# PERMIT

SEWAGE DISPOSAL SYSTEM

SUBDIVISION Ritz Estates ROAD 16984 Moss Meadow Way LOT 8, Block A

PLOT PLAN  
 LOT 8 BLOCK 'A'  
**RITZ ESTATES**  
 4<sup>TH</sup> ELECTION DISTRICT  
 HOWARD COUNTY, MARYLAND  
 SCALE: 1" = 60' MARCH, 1983

Location of

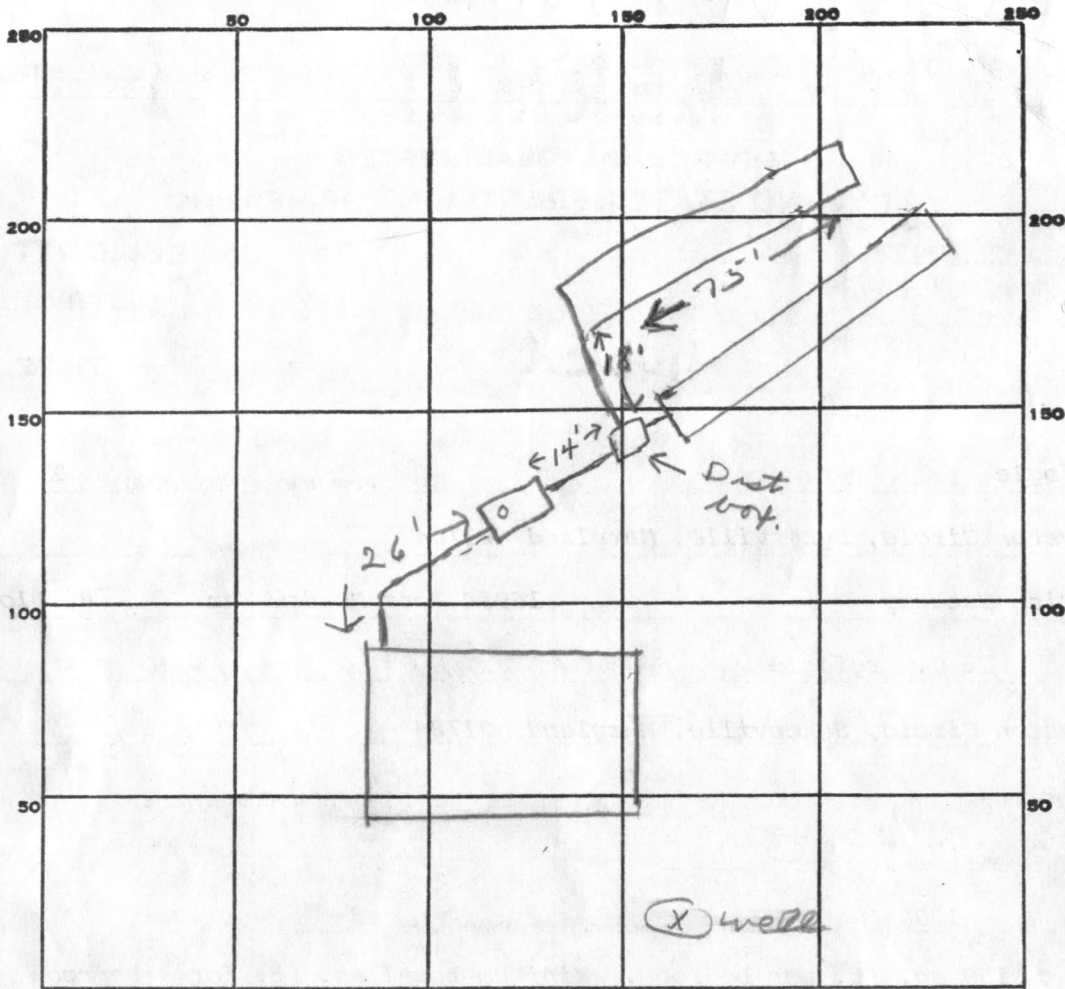
REMARKS 9/1/83 OK to add stone in trench. JF  
9/1/83 OK to add stone in # 2 trench. JF  
9/6/83 SYSTEM COMPLETED CW

Soil Profile

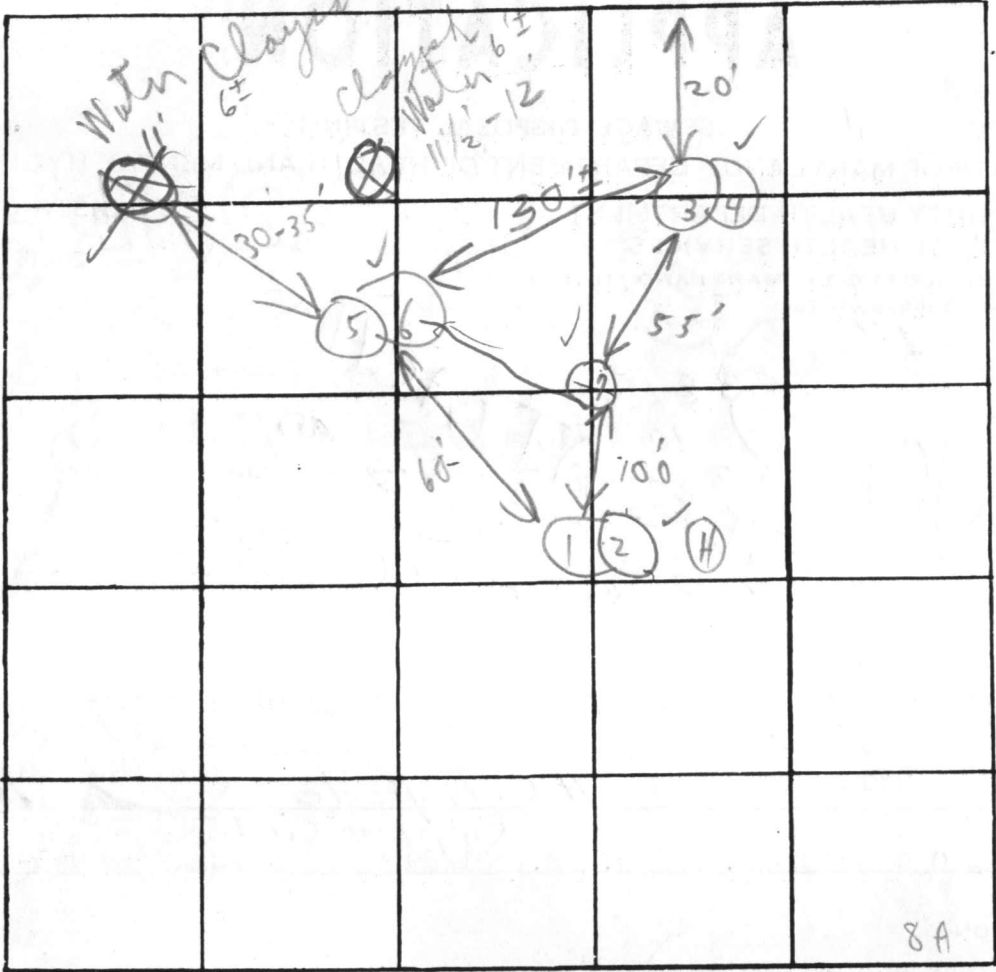
*Non-Buildable per plat signed by Dr. Joyce Boyd*

adequate area?  
test wet season

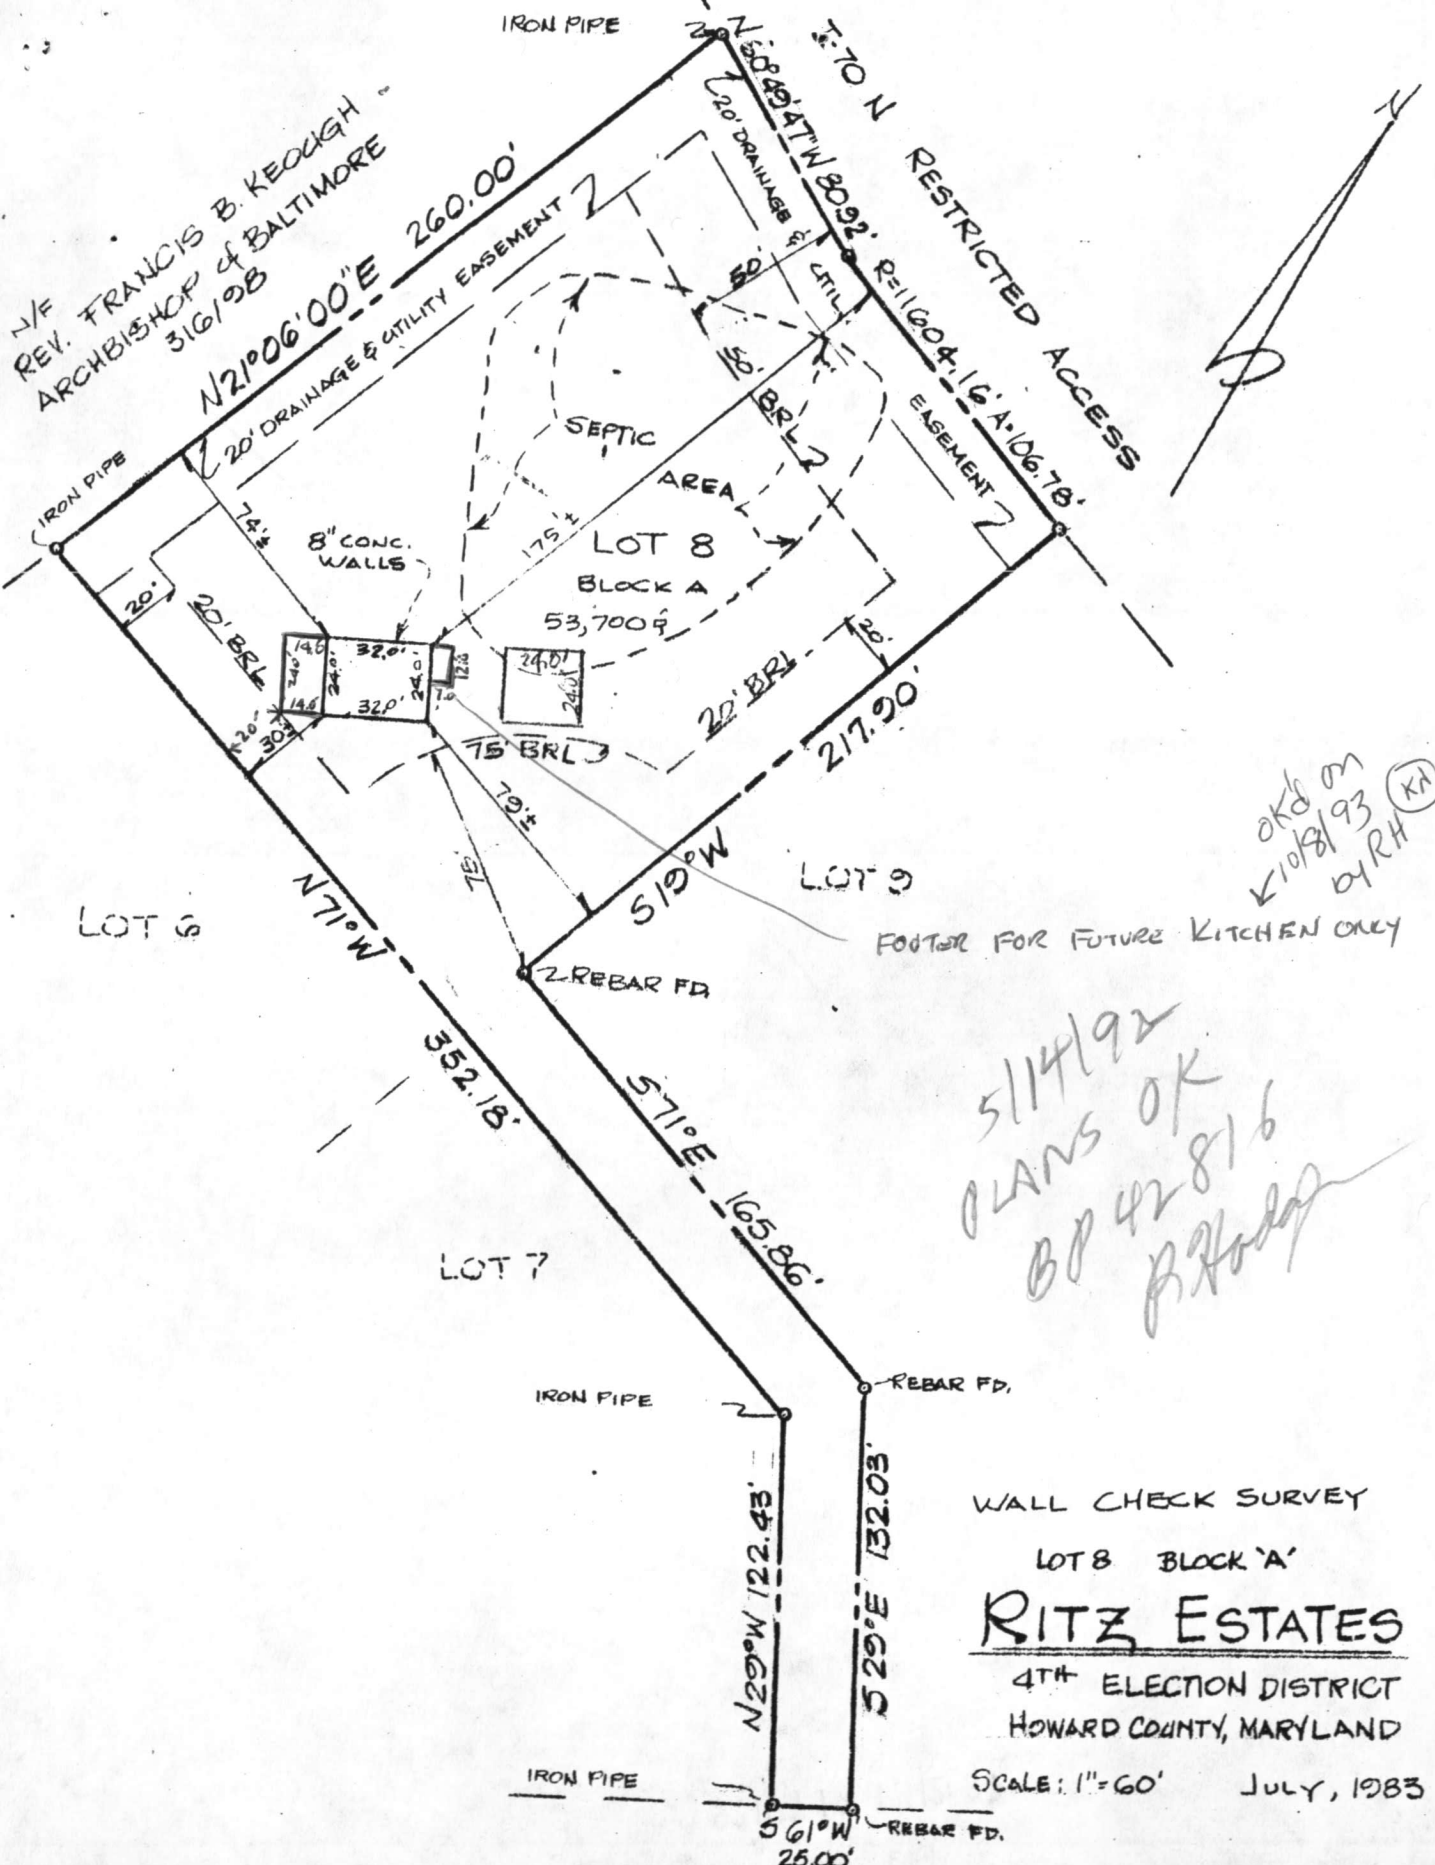
Can Raise House  
 outlet + Sewer pipe

Sketch OK. if  
 sewer pipe is raised 1 foot  
 throughout system & S.
